INDESIT company

Model type:
IDL705SUK

Commercial code:
F030043

N1045072FIG1

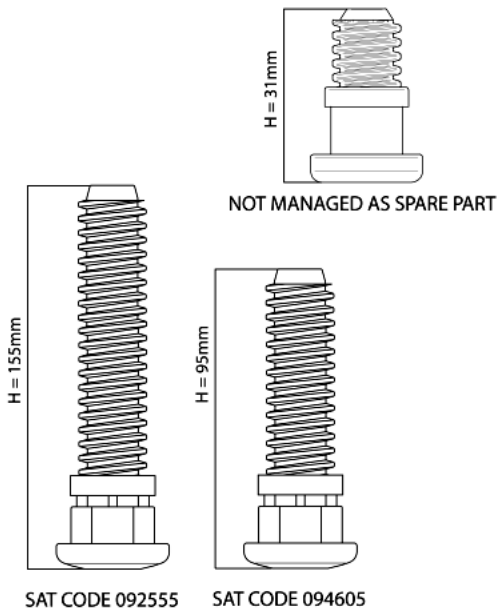
N1045072: Introduction of fixed rear foot H=31mm on free-standing models.

From serial no. 40218.0001, free-standing dishwashers affected by this modification have been equipped with new fixed rear feet (H=31mm).
The new foot replaces the adjustable one (H=155mm) Service code 092555; on the EVO3 range with TurboDry the new foot replaces the adjustable foot (H=95mm) Service code 094605.
The Spare Part Warehouse will continue to manage only 155mm and 95mm adjustable feet as they are interchangeable with the fixed 31mm foot.
The three feet are shown in illustration N1045072FIG1.

n1045069: Modification of racks and dispenser lid on EVO3 dishwashers

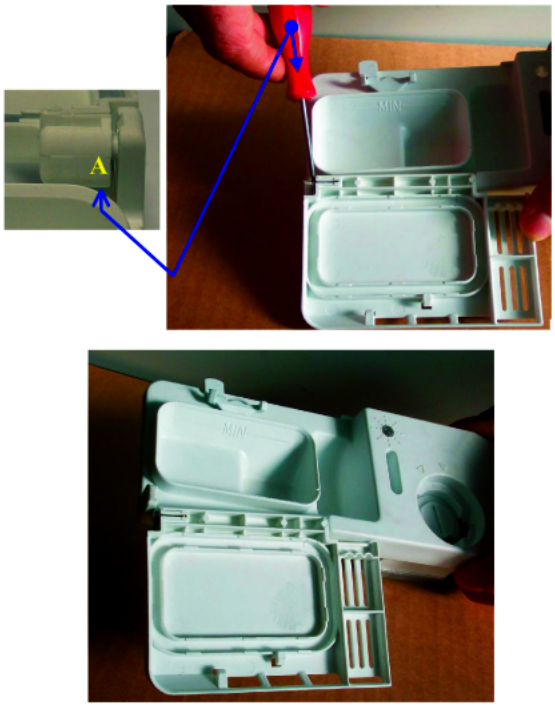
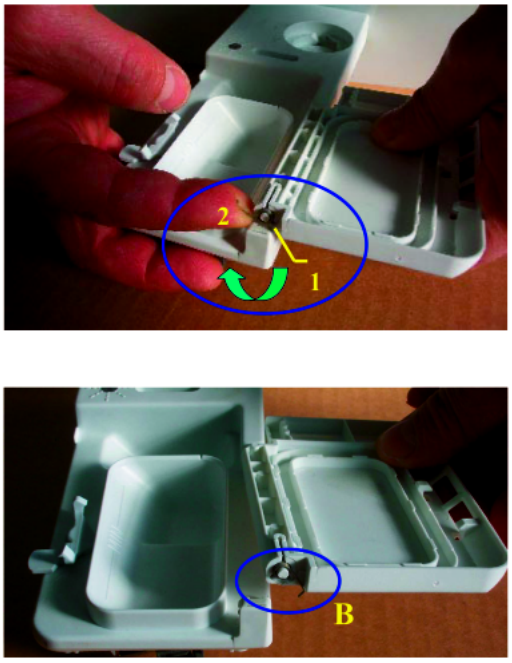
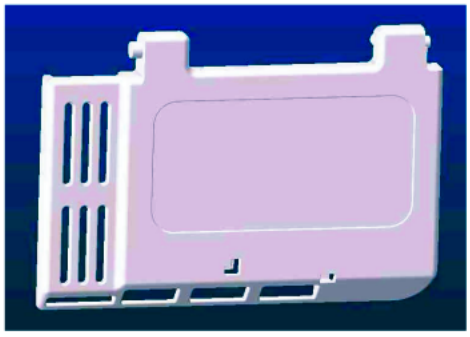
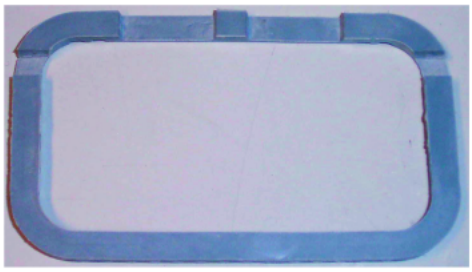
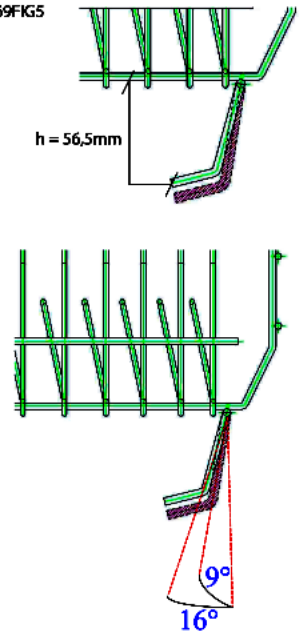
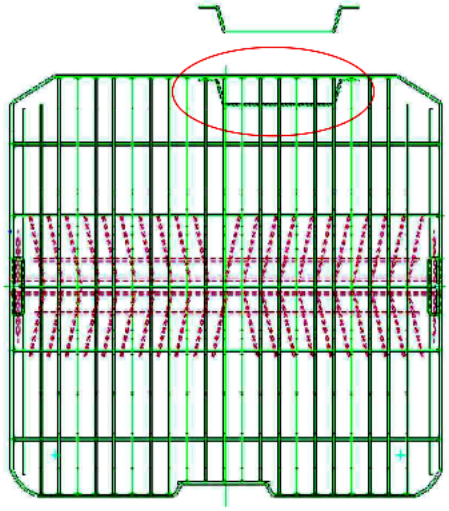
To obtain better dissolving of the detergent during the wash cycle, the following modifications have been made to EVO3 dishwashers:
- new dispenser lid, replacement code 098134 (see figure N1045069FIG4) created;
- upper racks modified with lid catch angle changed from 9° to 16° (see figure N1045069FIG5);
- MultiSystem lower racks modified with insertion of a spacer wire at the electric dispenser (see figure N1045069FIG6).

Lid installation instructions:
1) prise the lid out of the dispenser seat using a small screwdriver at point A (figure N1045069FIG1);
2) replace the lid, checking that release spring B (figure N1045069FIG2) is in place; before fitting the new lid load the spring from position 1 to position 2 (figure N1045069FIG2);
3) fit the lid in its special seat and check for correct operation (figure N1045069FIG3).
Lid closing may be harder for the first few cycles after replacement, due to settling of the material.

The upper and lower racks have the same spare part codes as the premodification items; Replacements Warehouse stocks have been replaced.

n1045083: Modification of filters on EVO3 60 cm dishwashers

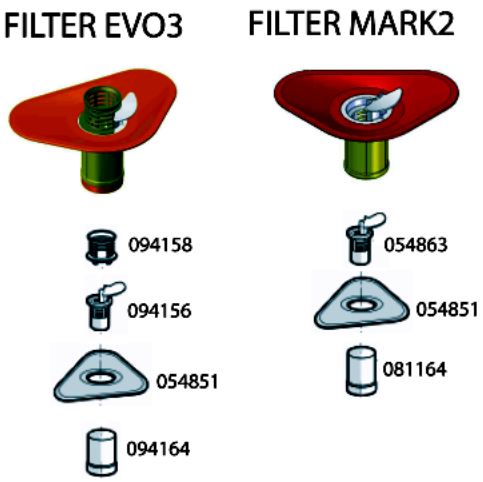
All dishwasher models affected by this modification have been equipped with the items listed below, in order to solve the drain pump clooging problem.

Introduction of:
Cylindrical plastic filter code 081164
Central filter code 054863

Elimination of:
Cylindrical plastic filter code 094164
Central filter code 094156
Central filter grid code 094158

The modification has been introduced progressively, starting from serial no. 40516.0001.

n1045085: Introduction of new litre counter turbine integrated on air-break.

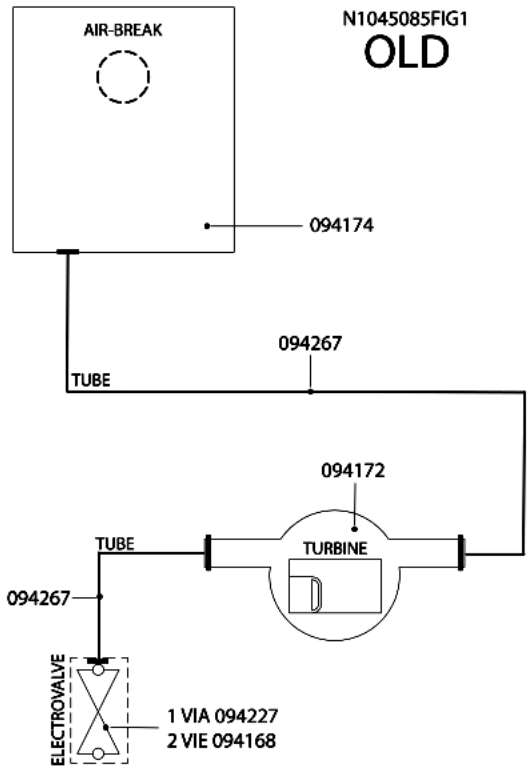
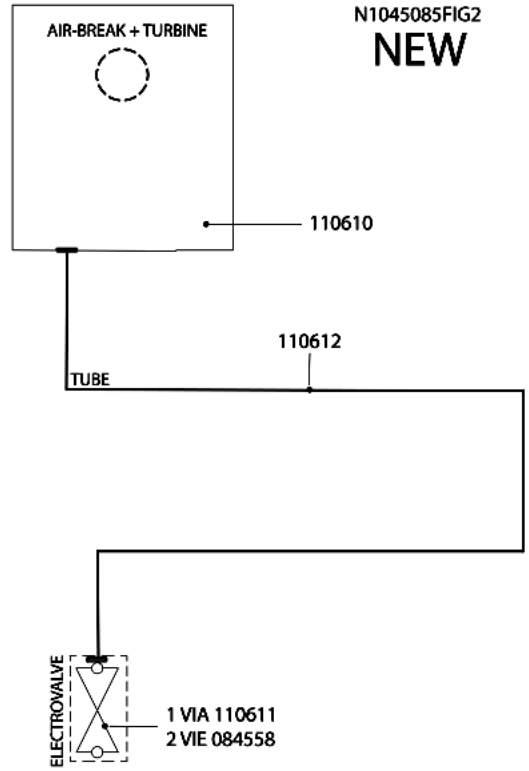
All dishwashers affected by this note have been equipped with a new litre counter turbine on the air-break.
Picture N1045085FIG1 illustrates the premodification structure, picture N1045085FIG2 the new structure.

AIR-BREAK:
new 110610;
premodification 094174;
the new item features a new integrated litre counter turbine and its water supply hose has a smaller diameter.

LITRE COUNTER TURBINE code 094172 has been eliminated.

SOLENOID VALVES:
new:
1-WAY code 110611;
2-WAY code 084558(Rohs 143737);
premodification:
1-WAY code 094227;
2-WAY code 094168;
the new solenoid valves have a smaller diameter drain hose fitting.

HOSES:
new solenoid valve hose/air-break code 110612;
premodification turbine hose/air-break code 094267;
premodification solenoid valve hose/air-break code 094267;
the new hose has a smaller internal diameter.

WIRING:
the litre counter turbine connecting cable is longer, but since the connector is the same, the new item can be used in place of the premodification one.
